Access Compliance Report Public Rights-of-Way (Curb Ramps)

Main Street: SIENNA_PKWY Cross Street: ZINNIA_ST Location: NE

ADA ID: RPRK211111135148 Ramp Type: Type 4 - Parallel Initial Pass/Fail: Pass Overall Compliance: No Severity Score: 25

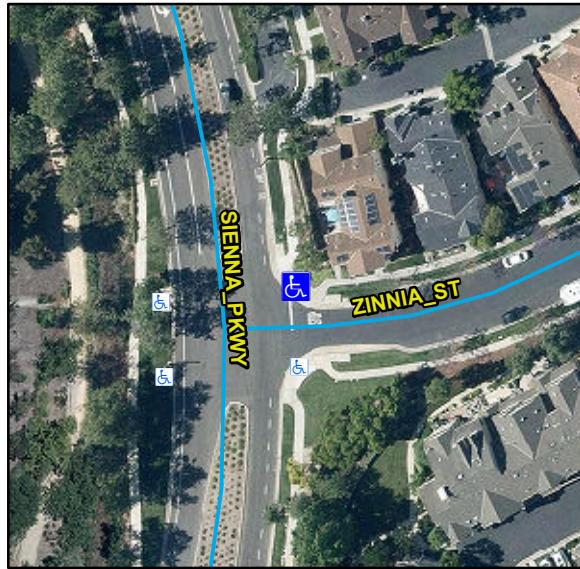
Compliance	Description	Data	Compliance	Description	Data
N/A	Ramp Length LT (in)	129	N/A	Ramp Length RT (in)	135
Yes	Ramp Width LT (in)	97	Yes	Ramp Width RT (in)	97
Yes	Ramp Run Slope LT (%)	4.3	Yes	Ramp Run Slope RT (%)	7
Yes	Ramp Cross Slope LT (%)	0.6	Yes	Ramp Cross Slope RT (%)	0.6
N/A	Landing Present	No	No	DWS Provided	No
N/A	Landing Length (in)	N/A	N/A	DWS Contrast	N/A
No	Landing Width (in)	N/A	N/A	DWS Length (in)	N/A
No	Landing Run Slope (%)	N/A	N/A	DWS Full Width	N/A
No	Landing Cross Slope (%)	N/A		DWS Offset Type	N/A
N/A	Landing Movement Obstructed?	No	N/A	DWS Offset Left (in)	N/A
	Landing Movement Type	Curb	N/A	DWS Offset Right (in)	N/A
N/A	Landing Shared	N/A			
N/A	Clear Space	Yes			
N/A	Clear Space To Crosswalk (in)	48			
N/A	Marked Crosswalk 1	No	N/A	Marked Crosswalk 2	No
	Crossing 1 Direction	W		Crossing 2 Direction	S
	Marked Crosswalk 1 Width (in)	N/A		Marked Crosswalk 2 Width (in)	N/A
N/A	Ramp Inside Crosswalk 1	N/A	N/A	Ramp Inside Crosswalk 2	N/A

Crossing 1 Slope (%)	3.1		Crossing 2 Slope (%)	0.6
	Crossing 1 Cross Slope (%)	1.6		Crossing 2 Cross Slope (%)	0.6
Yes	Gutter Ponding	No	Yes	Curb Slope	4.4
Yes	Gutter Lip Height (in)	0		Road Run Slope (%)	1.6
No	Gutter Run Slope (%)	6.6		Road Cross Slope (%)	0.7
Yes	Gutter Cross Slope (%)	0.6	No	Perpendicular Joint Present	No
Yes	Overall Surface Condition	Acceptable			
	Cross Gutter Present?	No		Spandrel Present?	No
	Replace Cross Gutter?	N/A		Replace Spandrel?	N/A

Remove & Replace Curb Ramp With Two New Directional Ramps or Equivalent. Remove & Replace Gutter.
